CITY OF FREDERICKSBURG HISTORIC REVIEW BOARD

TUESDAY, JUNE 15, 2021

7. CERTIFICATE OF APPROPRIATENESS APPLICATIONS

Application Number: 21-57
Date: June 15, 2021
Address: 412 W Schubert
Zoning: R1
Owner: Jeffrey & Lisa Zook
Applicant: Gary Williams
Rating: Low
Proposed Modifications: addition, fenestration changes

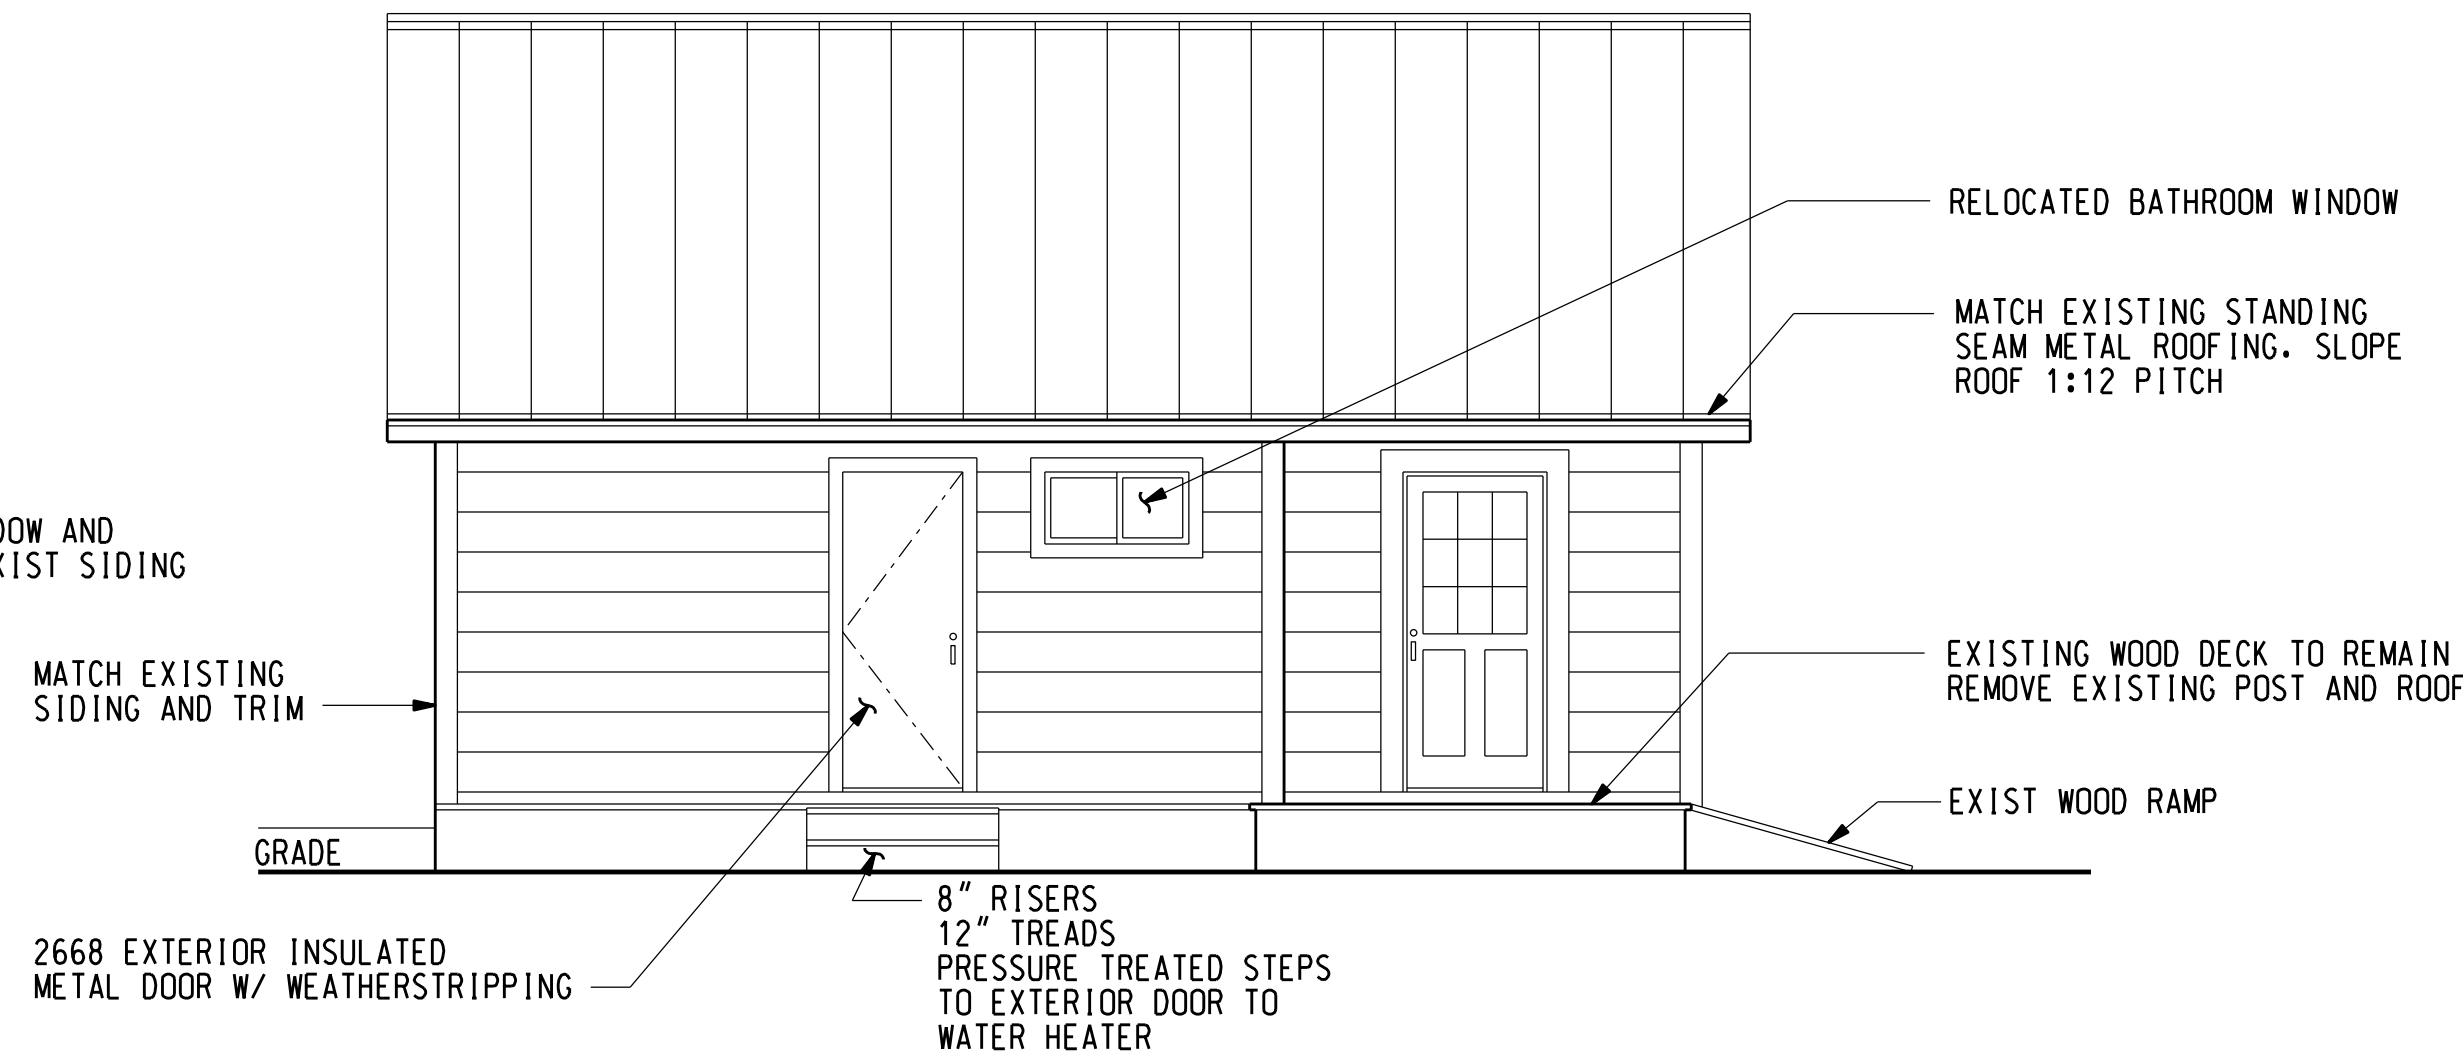
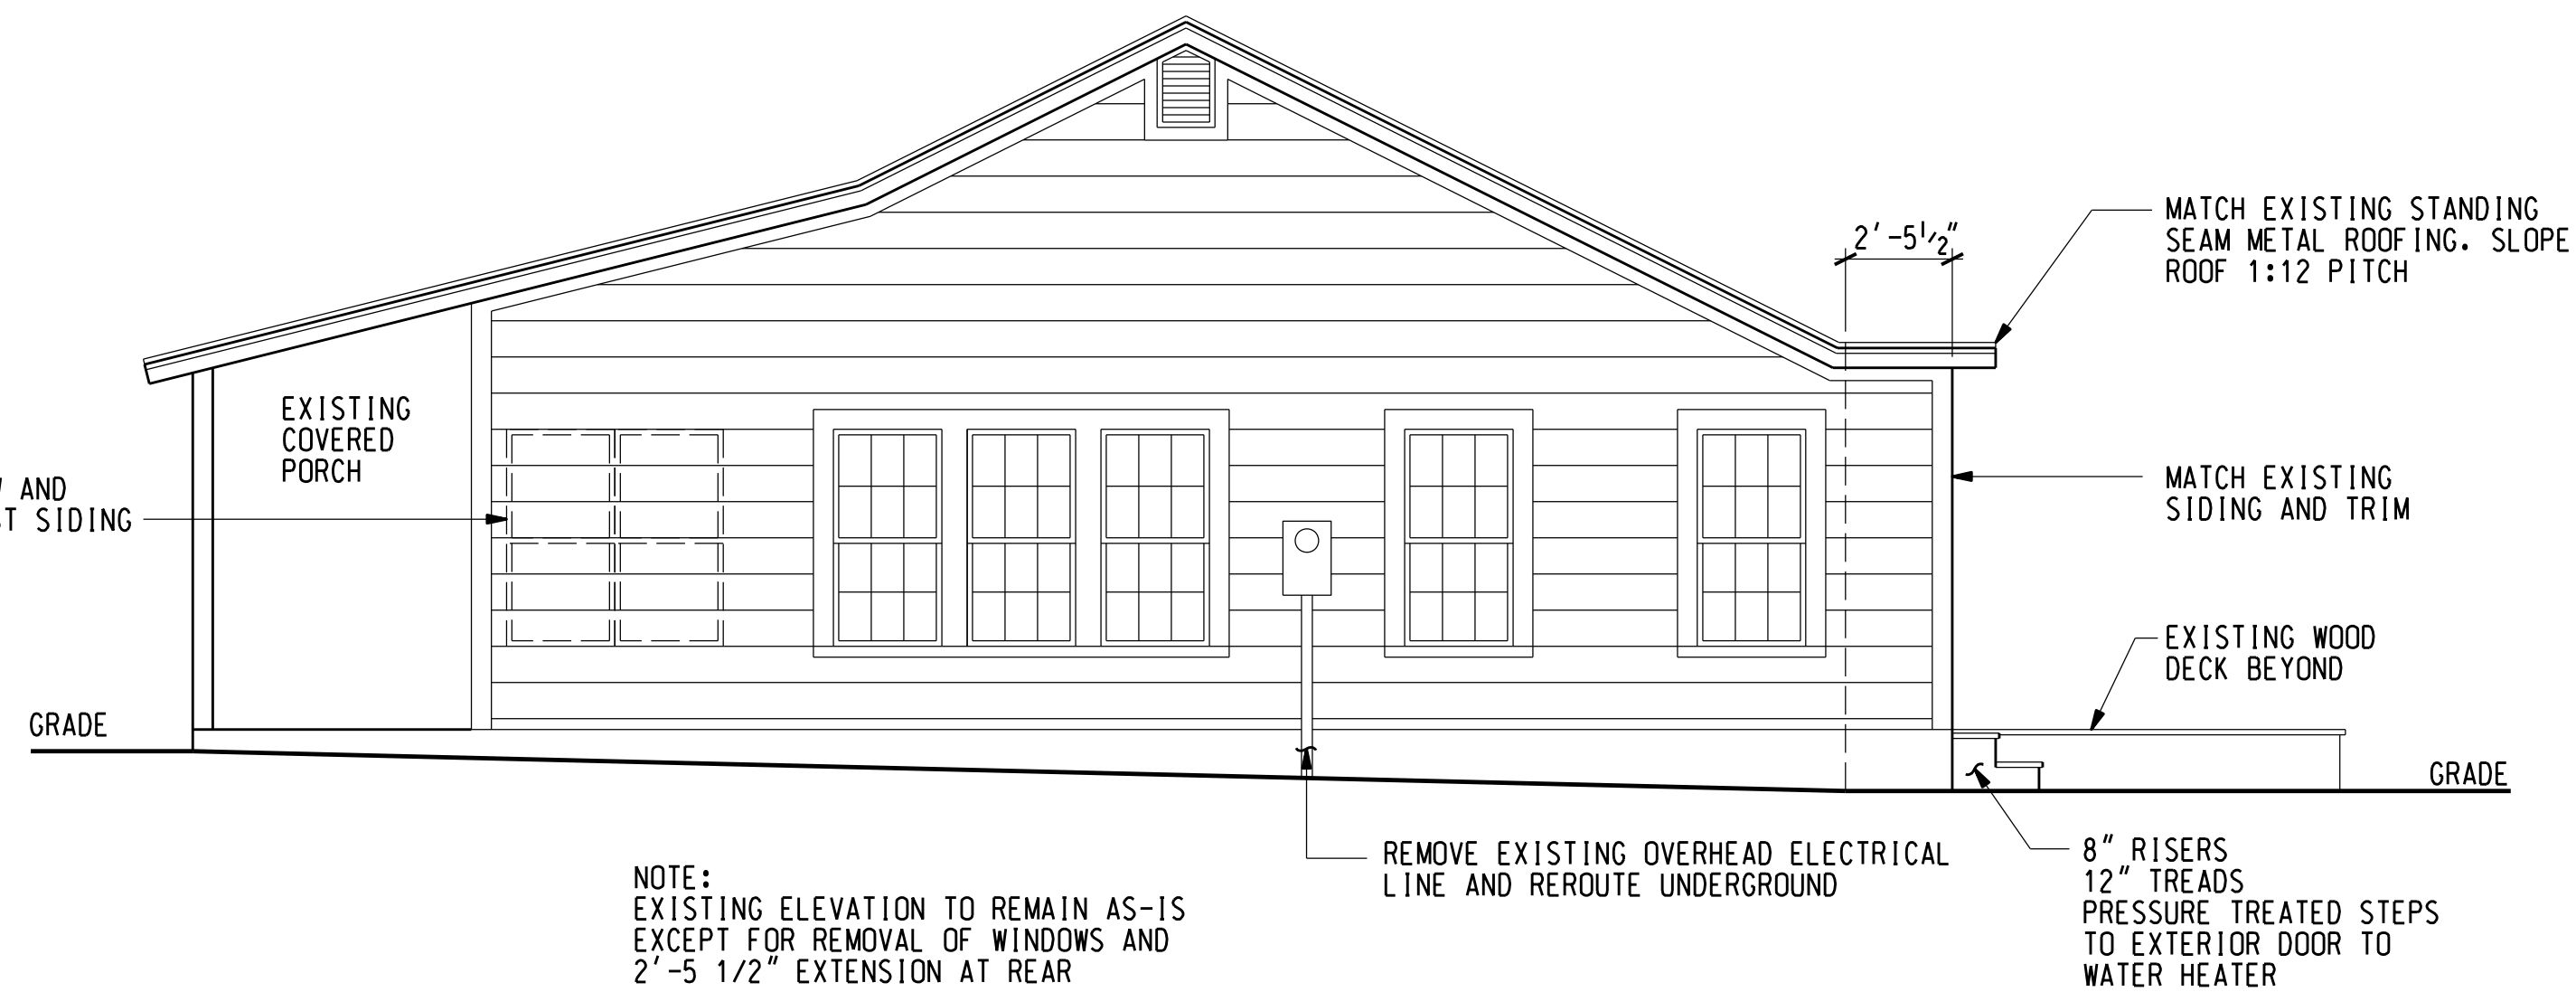
1. an addition of approx. 2'-6" across the back of the house to add a closet to one bedroom and add space to the only bathroom. The addition's exterior will match the existing house in materials and color.
2. The front elevation and right elevation will have two windows removed so another closet can be added to the front bedroom. the roof line from the front will be unchanged.
3. The roof over the covered deck in the backyard will be removed and the deck repaired.
4. Repair front fence
